68 SMITHE STREET (COMPLETE APPLICATION)
DE415916 - ZONE CD-1

DEVELOPMENT PERMIT STAFF COMMITTEE RECOMMENDATION: APPROVE

SECTION NO.	SECTION BB-CC
DATE	2007-01-15
SCALE	1:200
PROJECT NO.	2007-001
DATE	2007-01-15
SCALE	1:200
SECTION	BB

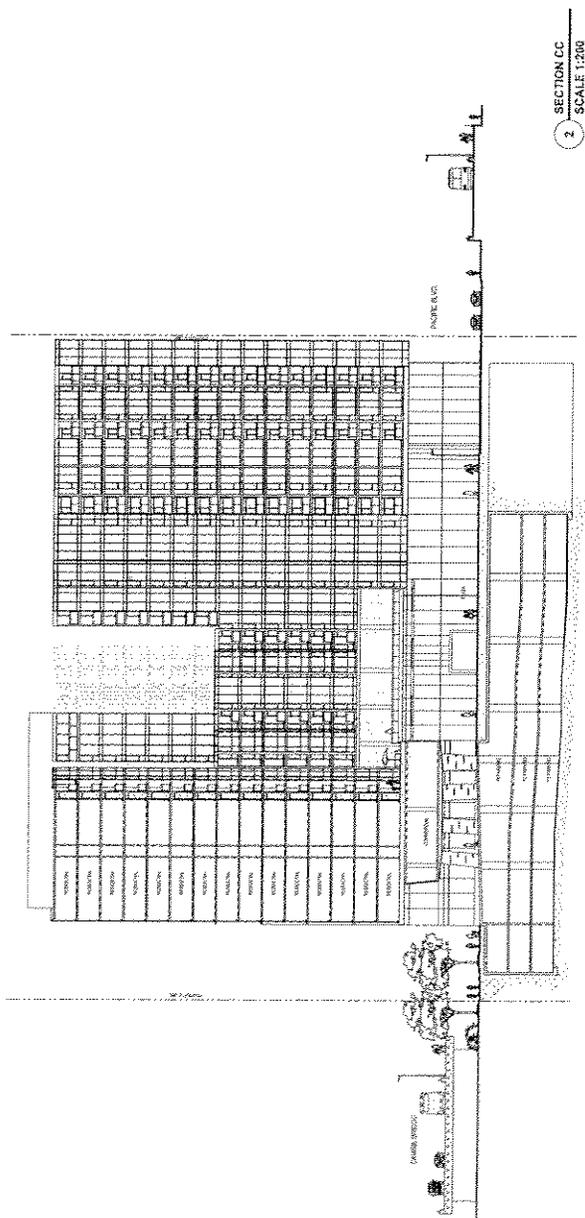
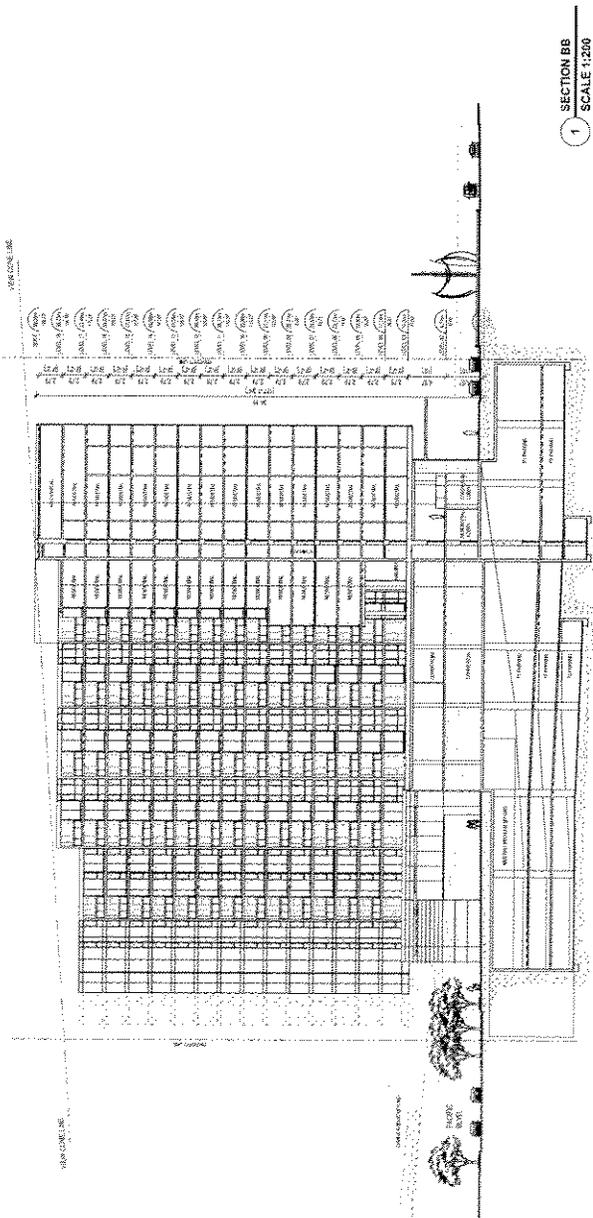
Note to Applicant: A portion of an unidentified structure is depicted projecting into the View Cone on Section BB of Sheet No. A3.02.

LEVEL 1: Landscape Plan

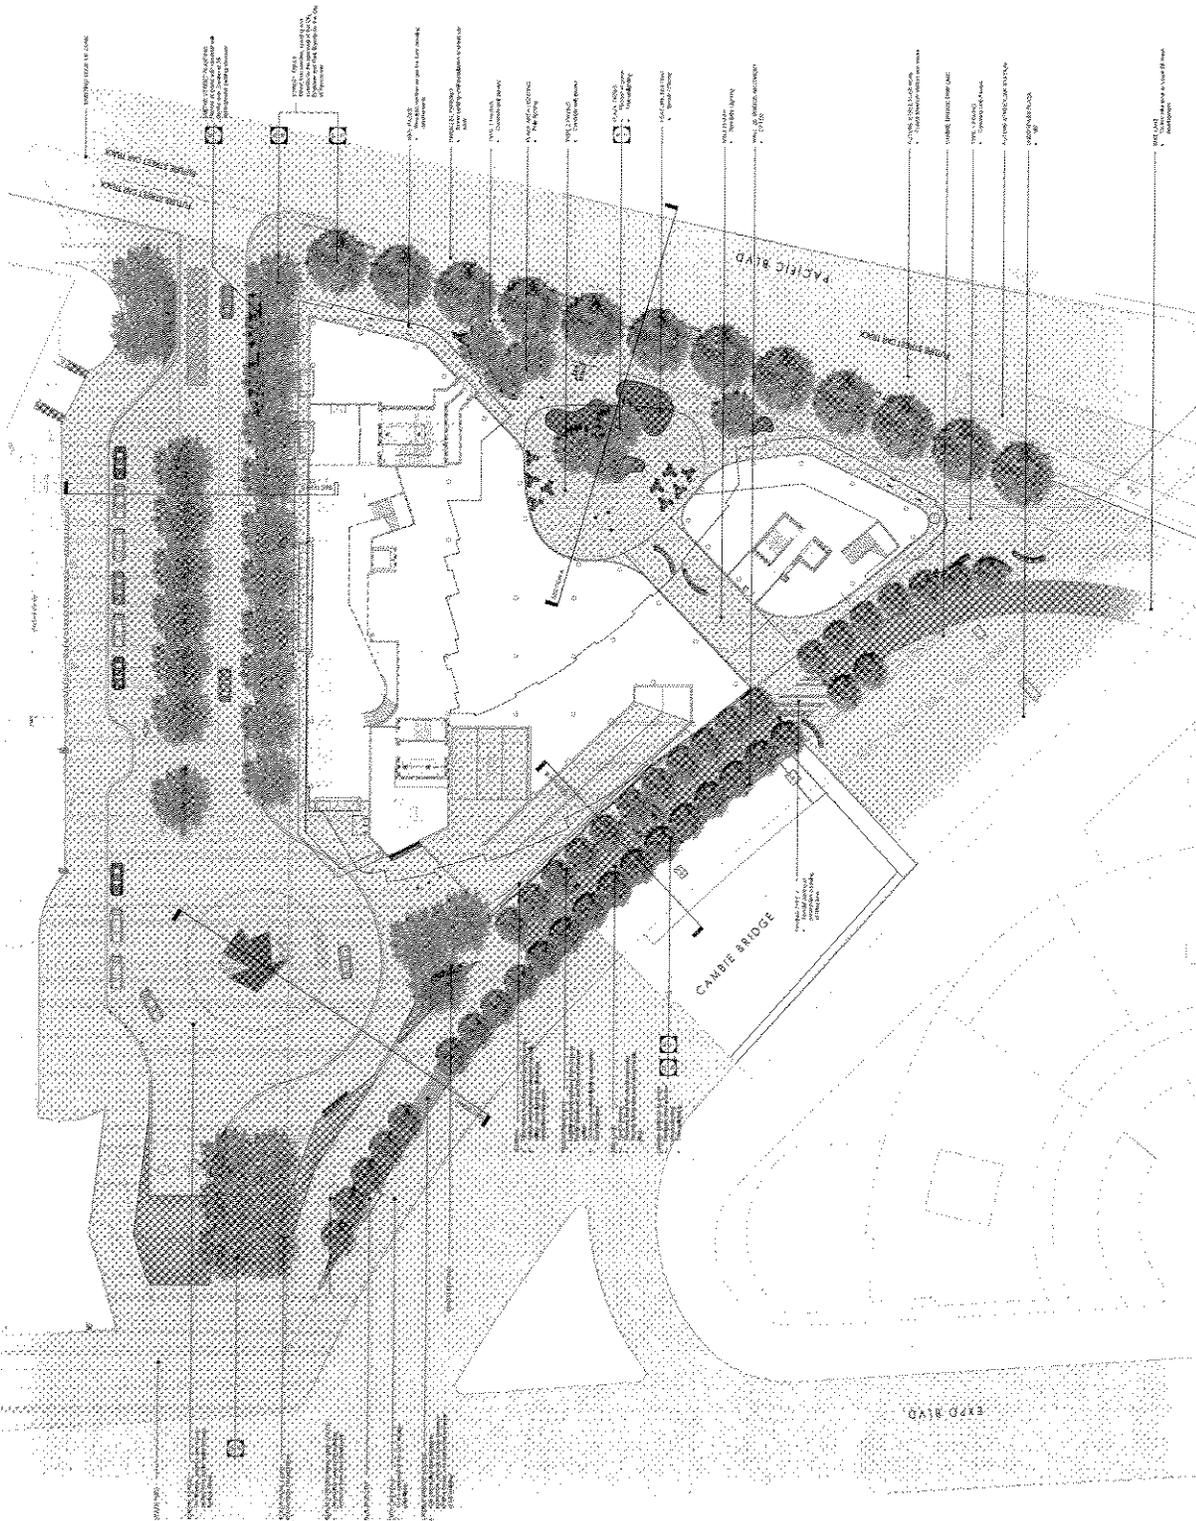
- A.2.9 deletion of the trees, the "feature seating" (bench/planter) and other seating from the Pacific Boulevard sidewalk Statutory Right-of-Way (SRW) area, as shown on L1.0;
